MFN 06-225

**Subject: Response to NRC Request for Additional Information Letter No. 4
Related to ESBWR Design Certification Application – ESBWR
Scaling Analysis – RAI Number 6.3-1**

RAI Number 6.3-1

NRC RAI 6.3-1

Figure 9. **Schematic of the 4500 MWt ESBWR Containment Systems during the Long Term PCCS Phase**

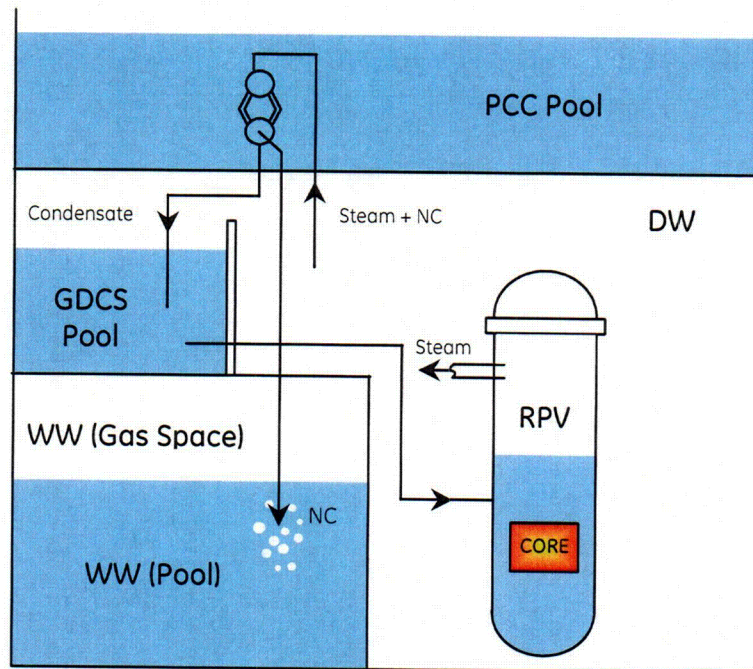
1. *Provide an updated scaling analysis (similar to Reference 2) showing plots for CCWL vs. reactor pressure for modified ESBWR design and tests, including the revised Pi-values calculated using inter-connected volumes and components.*
2. *Provide a comparison of revised ESBWR Pi-values with that of the tests for other phases of LOCA.*
3. *Provide justification as to why confirmatory scaling analysis similar to the approach taken in Reference 2 for the blowdown and GDCS transition phases are not necessary for other phases of LOCA, such as long-term cooling phase.*

The purpose of the simplified confirmatory analysis for the late blowdown and GDSC transition phases is to show that the pair of differential equations that govern the RPV transient pressure and liquid inventory can be simplified and solved numerically to directly demonstrate similar responses for the ESBWR and the test facilities. In the process, the key phenomena that govern the relatively rapid changes in the RPV pressure and liquid inventory during these phases of the LOCA transient are identified and clarified. This situation is in marked contrast to the long term cooling (PCCS) phase of the LOCA transient where pressures in the RPV, DW and WW are essentially equal and changes are occurring in a quasi-static manner.

Figure 9 shows a schematic of the 4500 MWt ESBWR containment systems during the long term cooling phase. The steam generation rate inside the RPV is directly proportional to the decay heat and the entire amount of steam discharges into the Drywell (DW) through the break (MSLB or FWLB) and the ADS. The steam discharge rate is independent of the type of break and the RPV and the drywell are effectively uncoupled. The decay heat steam along with a small amount of residual DW noncondensable flows into the PCC, which is submerged in the PCC pool above and outside the containment. The steam is condensed in the PCC tubes and the condensate flows into the GDSC pool. The residual DW noncondensable eventually moves to the WW gas space and causes a small pressure increase. Figure 6.2-11 of [5] shows that during the long term cooling phase, the PCCS is capable of transferring all the decay heat to the PCCS pool outside the containment. Therefore, there is no further heat up of the WW pool and no WW gas space pressure increase due to steam generated in the RPV because of decay heat.

The minimal coupling between the different regions means that the Pi groups for the wetwell and the drywell can be evaluated separately without reference to the other regions. Based on these considerations, GE believes that no additional or confirmatory scaling analysis is required for the long-term cooling phase.
